# 4470 FM 1863

# Traffic Impact Analysis - REVISED

Re: Review # 2 Comment for Bulverde Convenience Store

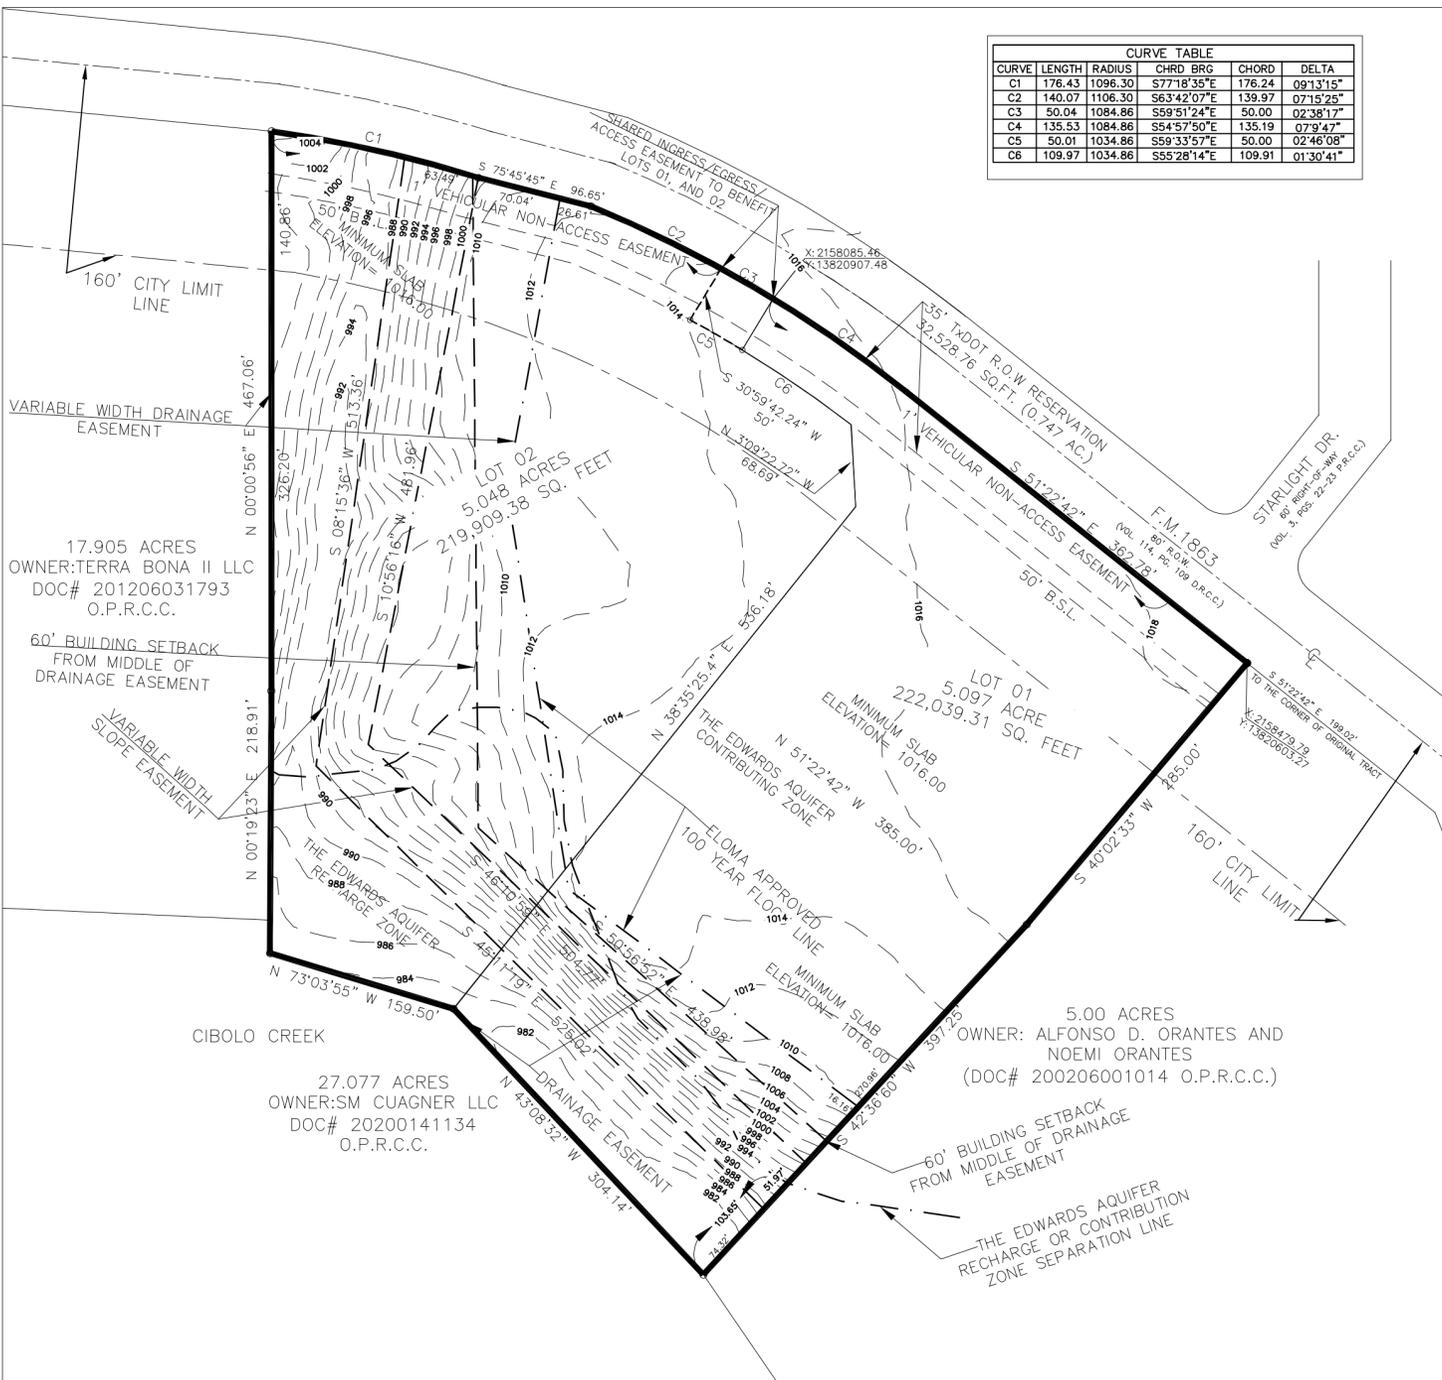
**1. New Comment: Per the General Design regulations of the Subdivision Ordinance, all lots shall have a minimum frontage as outlined in subsection 2.03(c)(iv). Lot 3 currently does not meet this requirement. Unless a variance is requested, the 30' ingress/egress and shared access easement does not suffice. If you would like to pursue a variance, contact Suzanne Williams, Director of Planning with the City of Bulverde.**

**Round 2: Each lot needs to have the heavier weighted border to clearly show the lot separations. Have the lot line weight match the perimeter lot lines.**

**Please see revised plat, now we have only 2 lots.**

**Revised as per request.**

Figure 4B

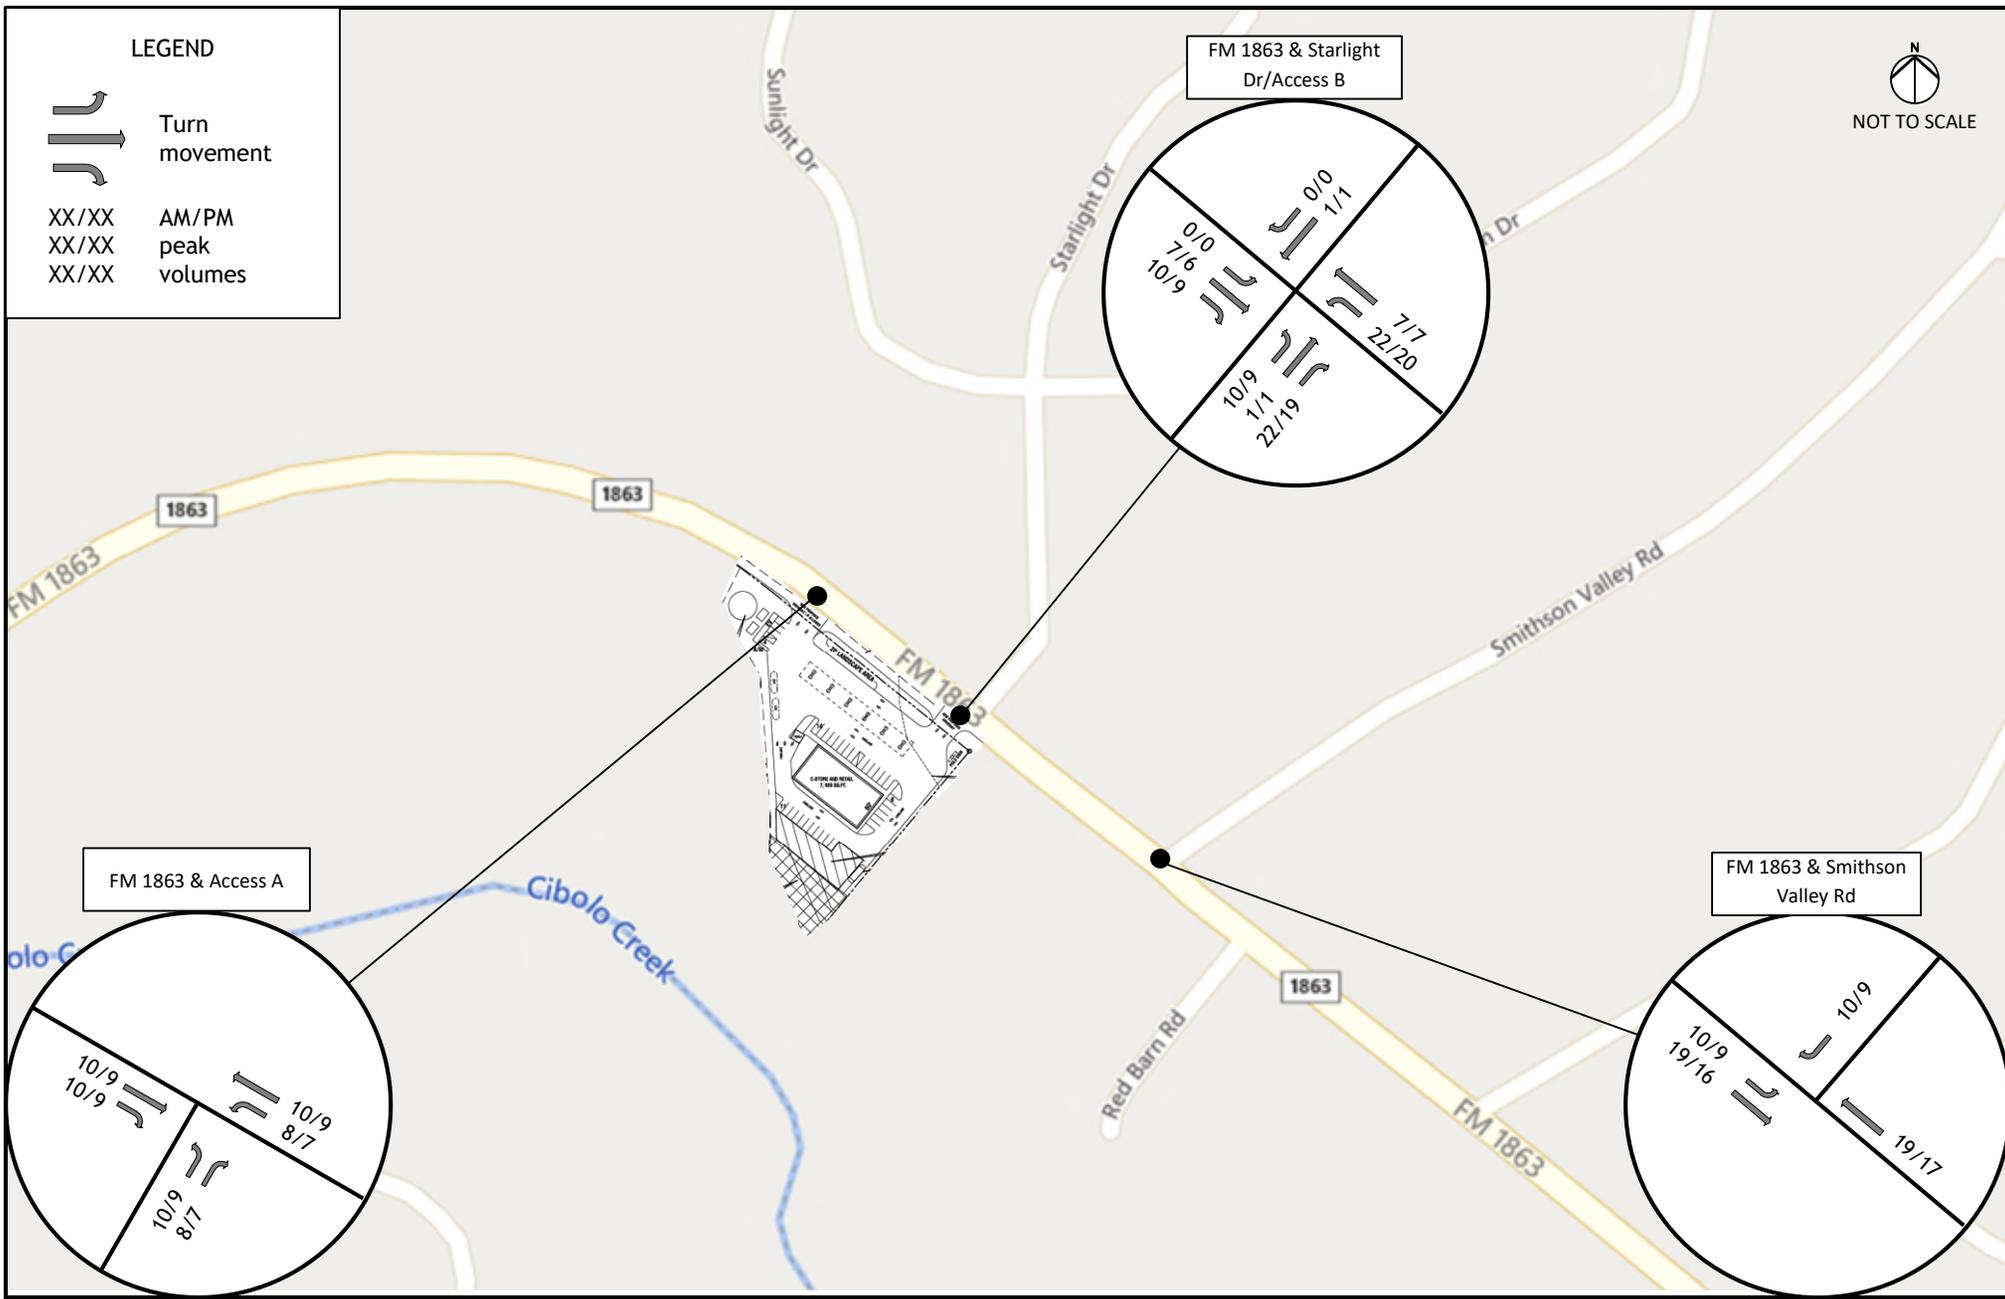
Please provide a  
 figure showing trip  
 distribution.

The resubmittal includes Figure 3B “Trip Distribution”, and added text regarding distribution at driveways.

## National Flood Hazard Layer FIRMette

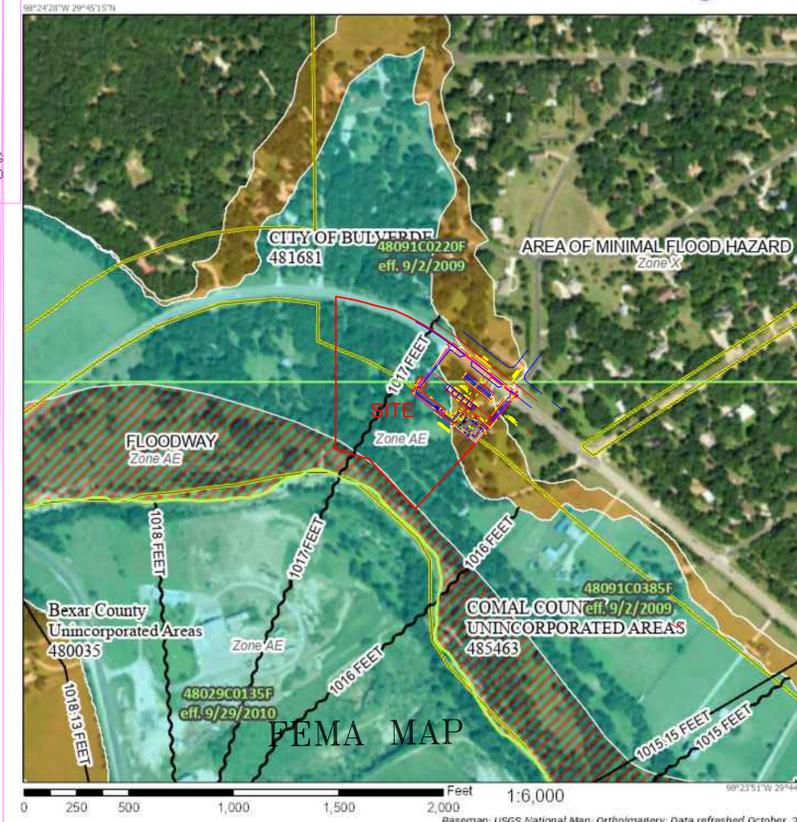
**Round 2: Comment not cleared. FEMA 1% annual chance floodplain line from FIRM must be used. Refer to the FEMA FIRMette (.pdf page 40 in drainage report), FEMA zone AE boundary looks much different than what is shown in preliminary plat. The Edwards Aquifer Recharge and/or Contributing Zone should be labeled or a note added describing all the plot(s) are located within zone..**
